ADDENDUM NO. 01

PROJECT: Pleasantville Union Free School District
Phase 2 - 2019 Capital Improvements Project

CPL PROJECT NO. 15131.01

DATE: March 5, 2020

PARTIAL THIRD FLOOR NEW WORK PLAN

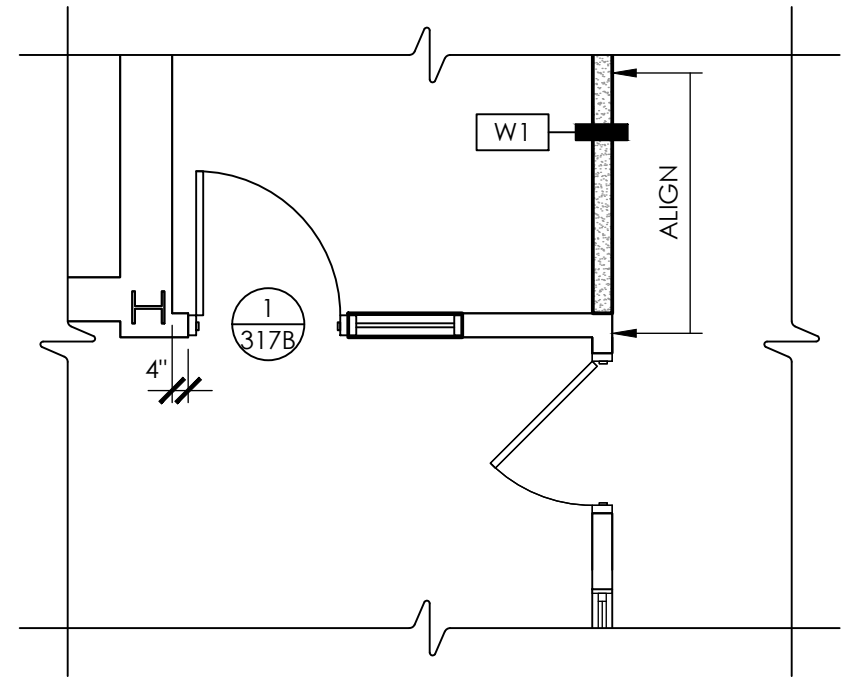
- 3.4 Drawing BRS A202: Delete in its entirety.
- 3.5 Drawing PHS A201: Revise portion of drawing per the attached sketch AD01-A01.
- 3.6 Drawing PHS A203: Replace with the attached revised drawing PHS A203.

3 SLAB INFILL DETAIL

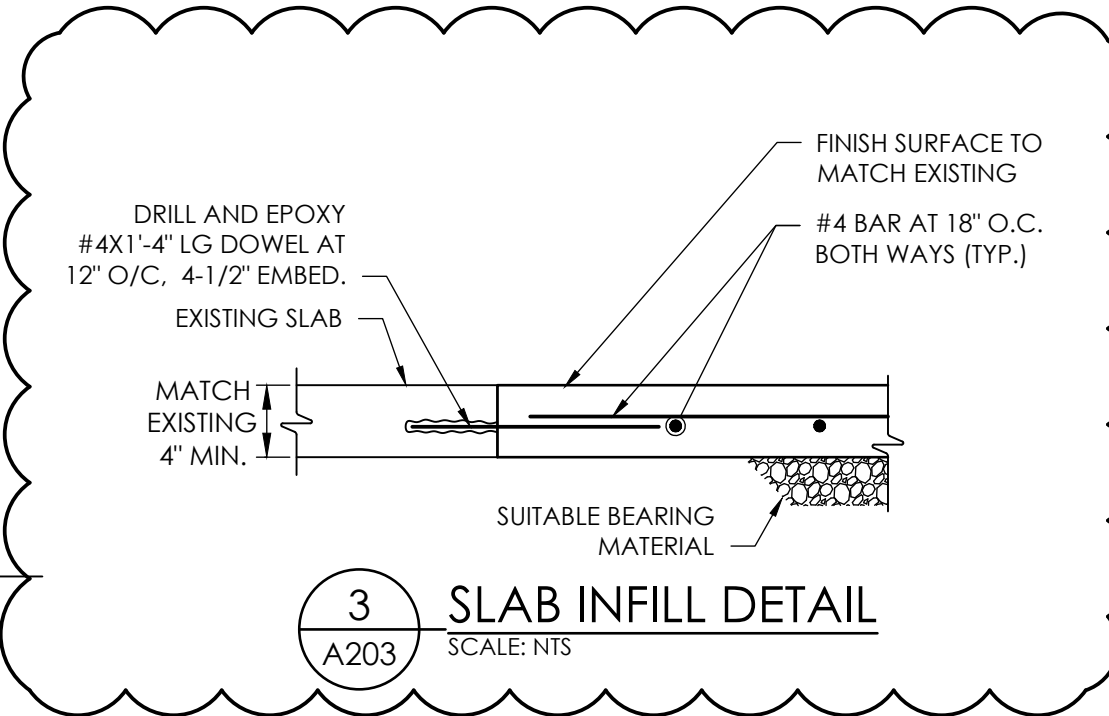
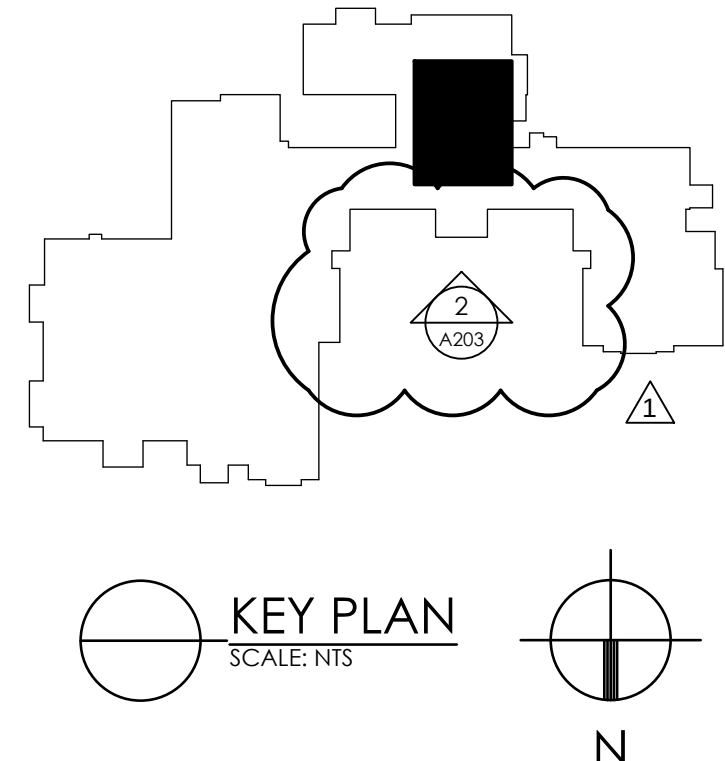
2.9.6 Part 1.5.A.8: At the end of the last sentence add, “Refer to drawing PMS A201 for slab infill detail.”

1 FIRST FLOOR HVAC DEMOLITION PLAN
H101 SCALE: 1/8" = 1'-0"

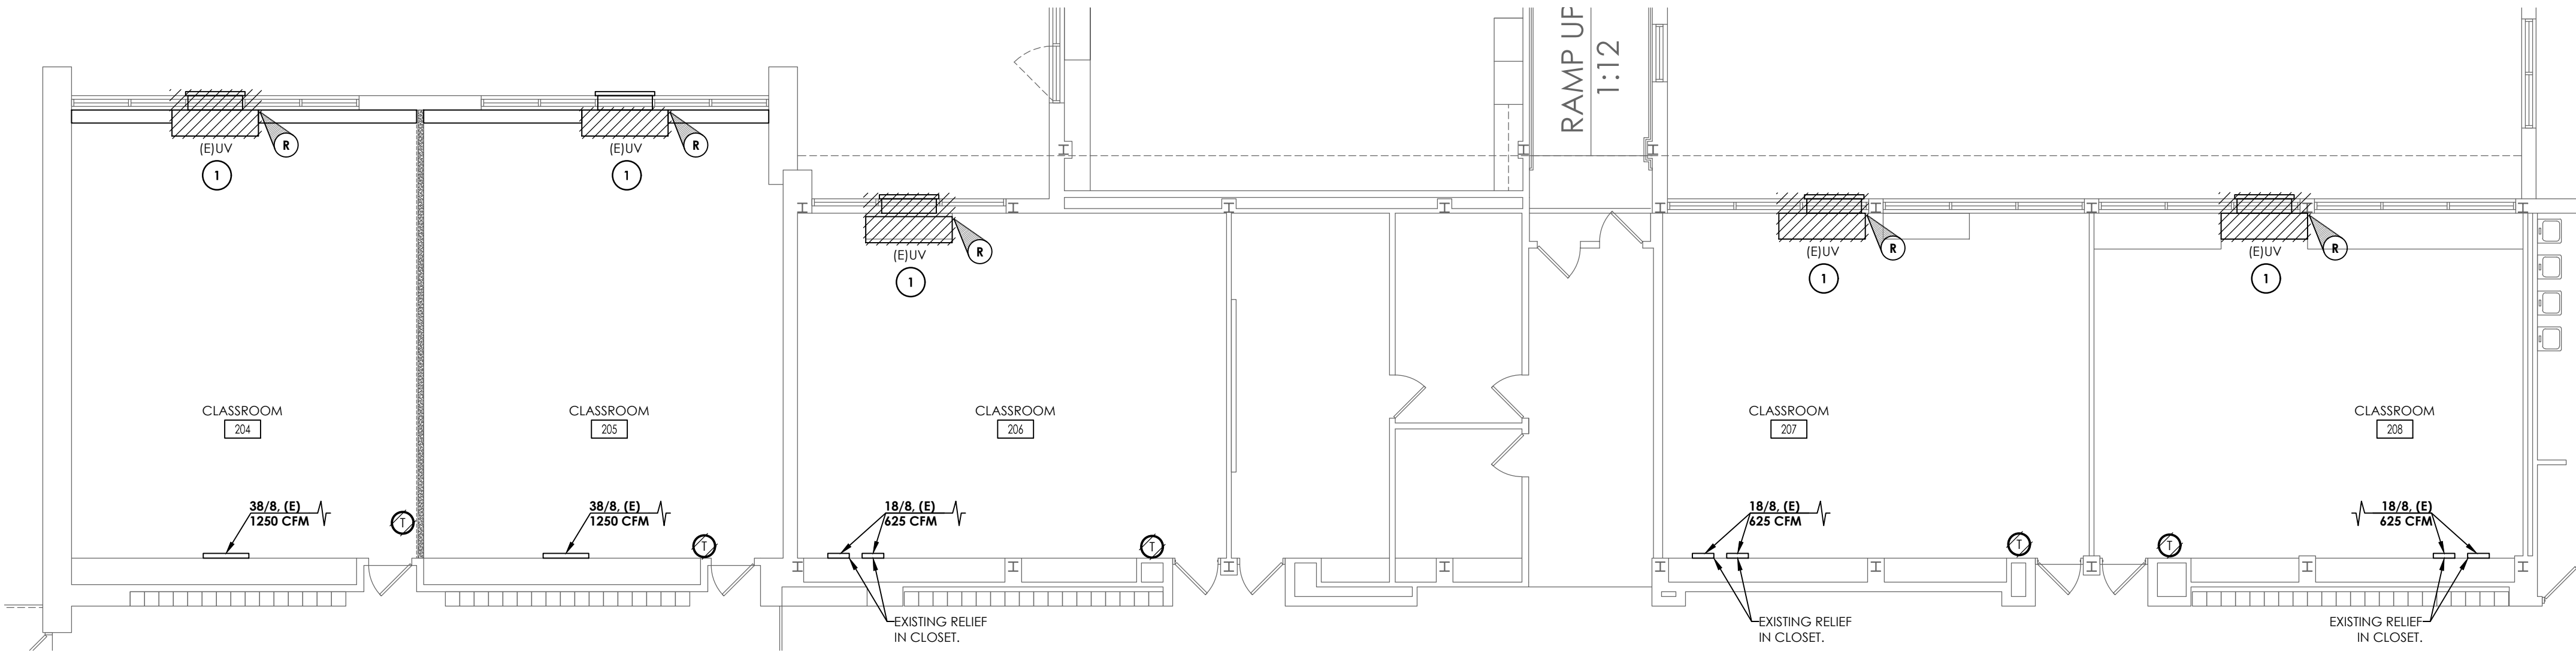
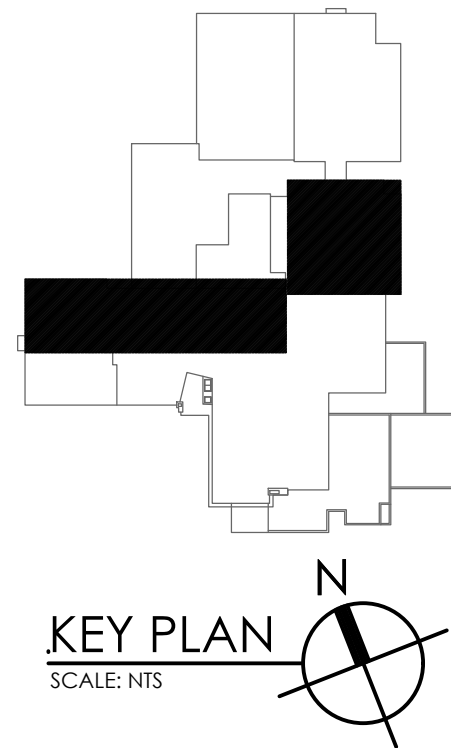
2.2.2 Under Mechanical after BRS H200, add “PMS H101 – Middle School First Floor HVAC Demolition Plan- ALT-MC-01”

- 3.14 Drawing GEN A803: Replace with the attached revised Drawing GEN A803.
- 3.15 After Drawing BRS H200, add the attached new Drawing PMS H101.
- 3.16 Drawing PMS E001: Replace with the attached revised PMS E001.
- 3.17 Drawing PMS E002: Replace with the attached revised PMS E002.
- 3.18 Drawing PMS E101: Replace with the attached revised PMS E101.
- 3.19 After drawing PMS E101, add the attached new Drawing PMS E102.
- 3.20 Drawing PMS E201: Replace with the attached revised PMS E201.
- 3.21 Drawing PMS P200: Replace with the attached revised PMS P200.

- C. MECHANICAL CONSTRUCTION
1. Alternate No. MC-01: Middle School Unit Ventilator Work
 - a. Description: Disconnect and remove existing unit ventilators as indicated on Drawing PMS H101.

1 SECOND FLOOR ELECTRICAL DEMOLITION PLAN
E102 SCALE: 1/16" = 1'-0"

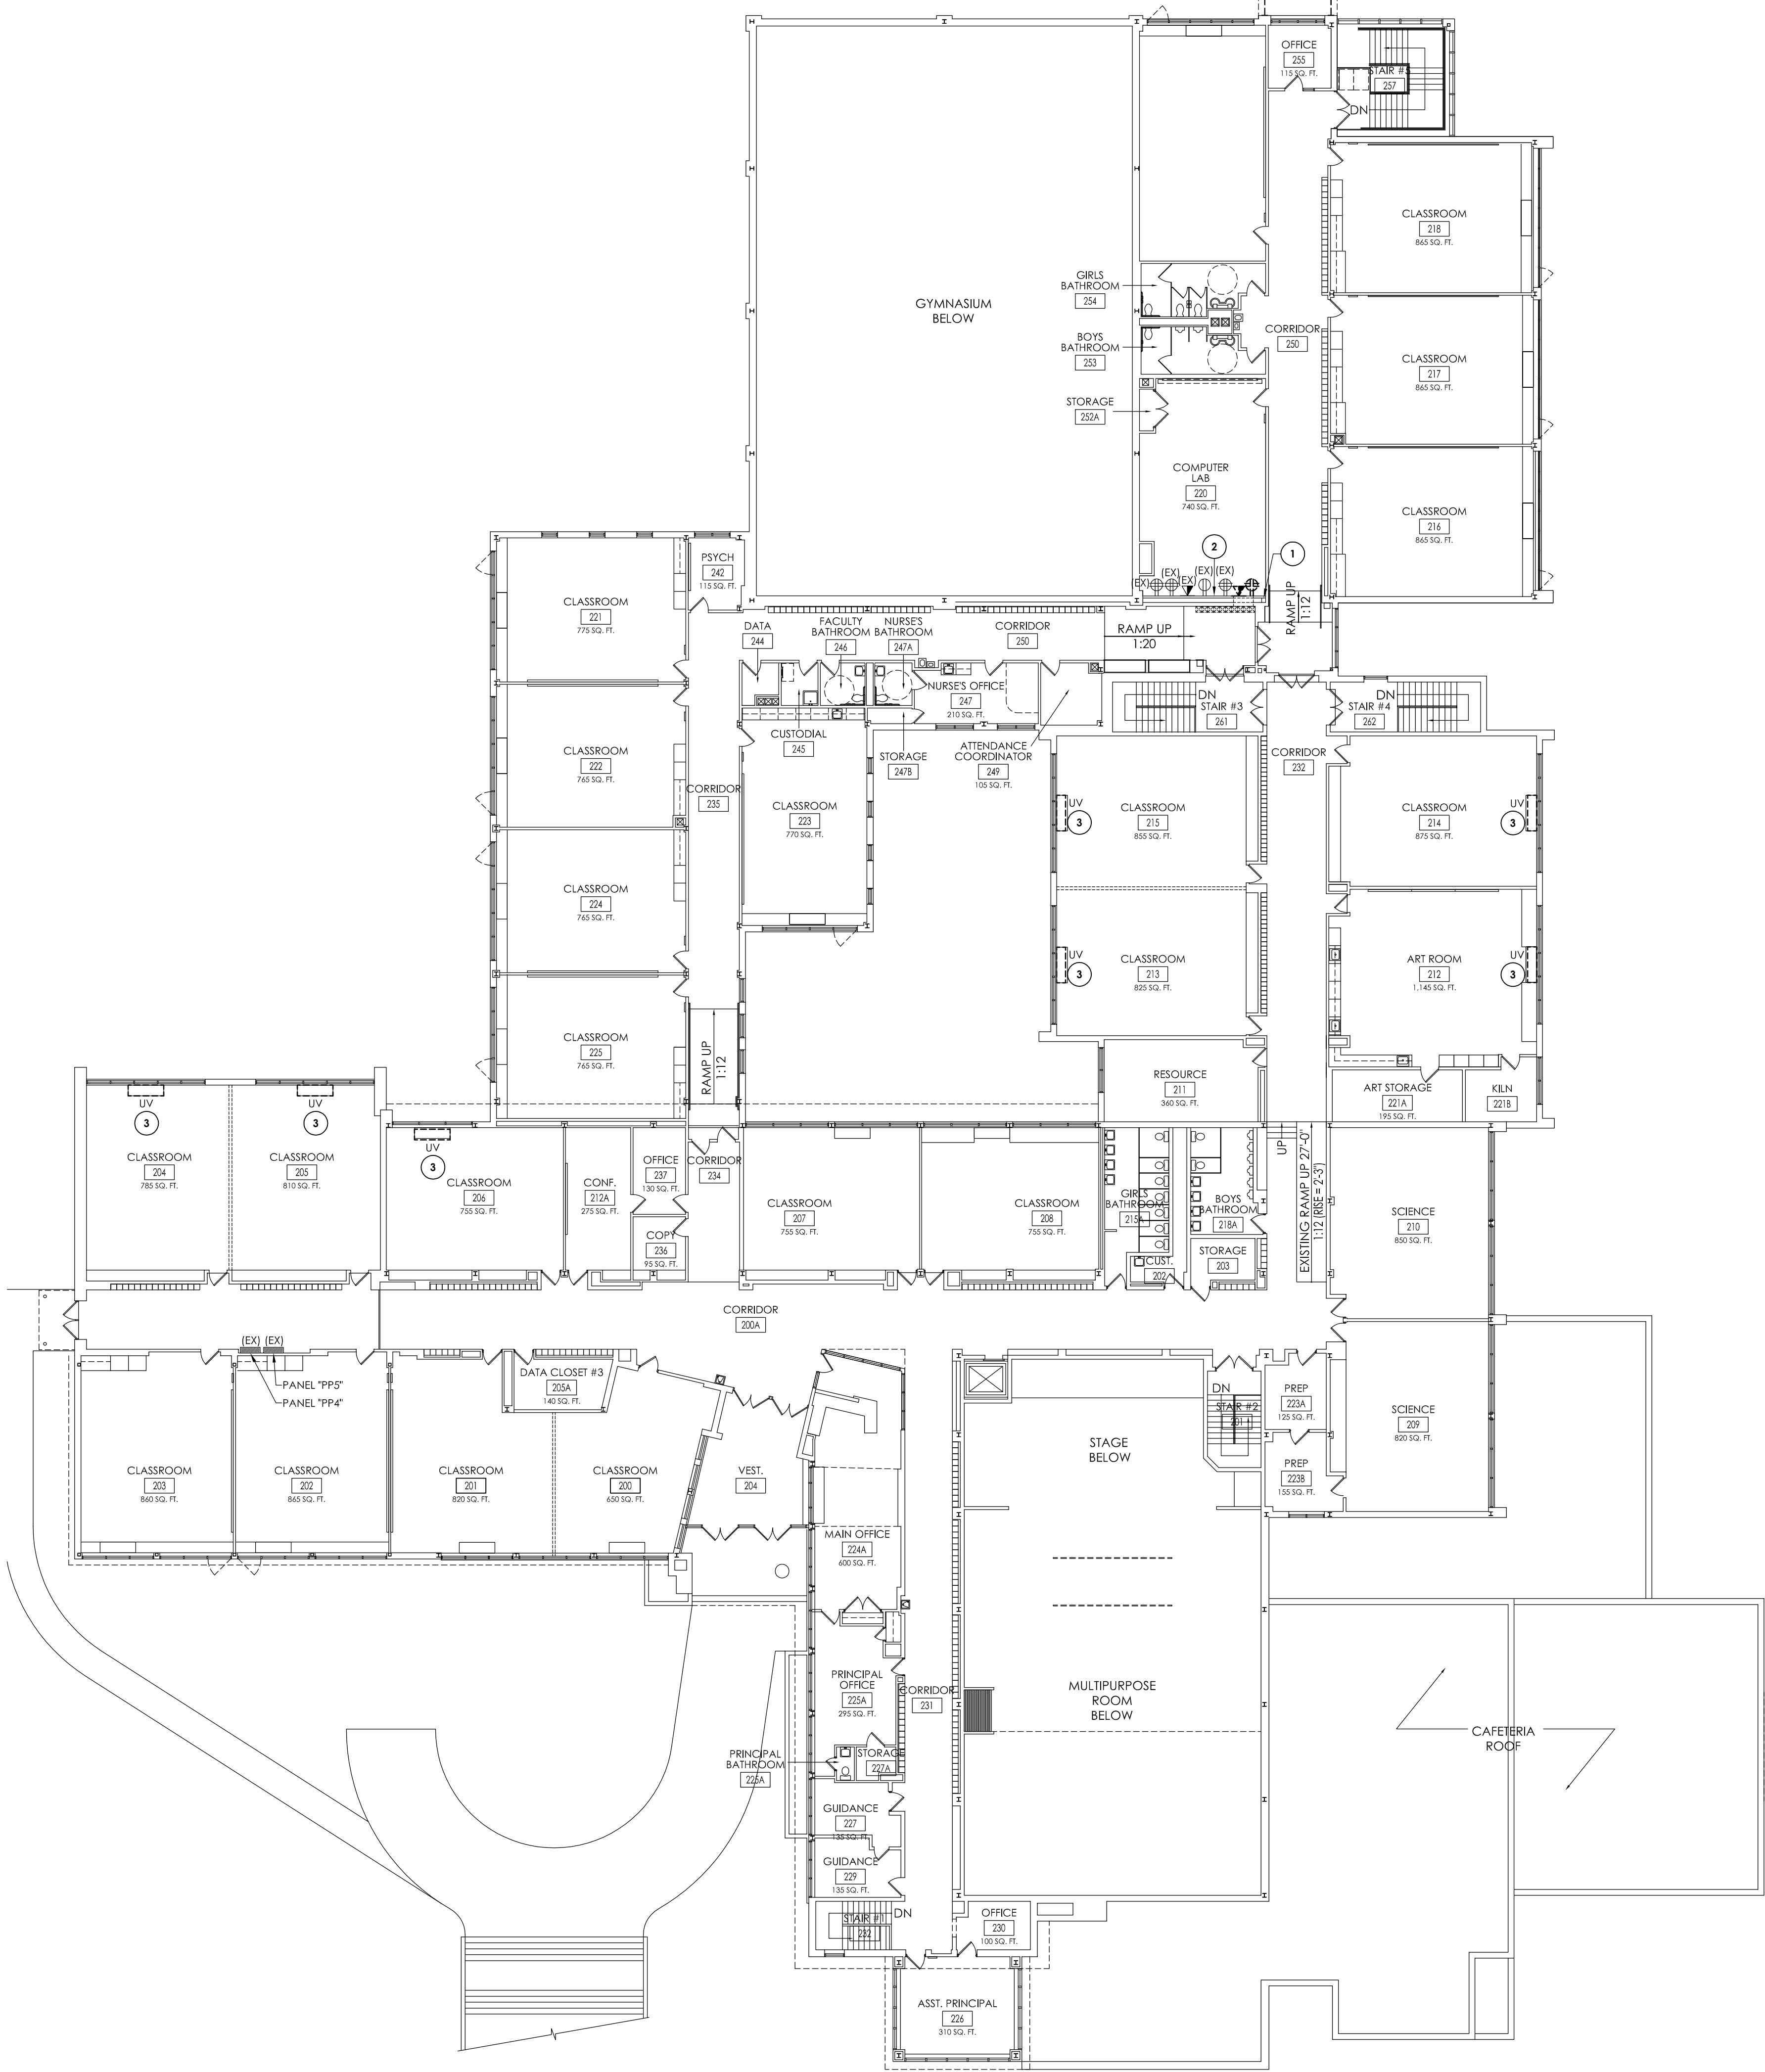
2.2.3 Under Electrical after PMS E101, add PMS E102 “Second Floor Electrical Demolition Plan”
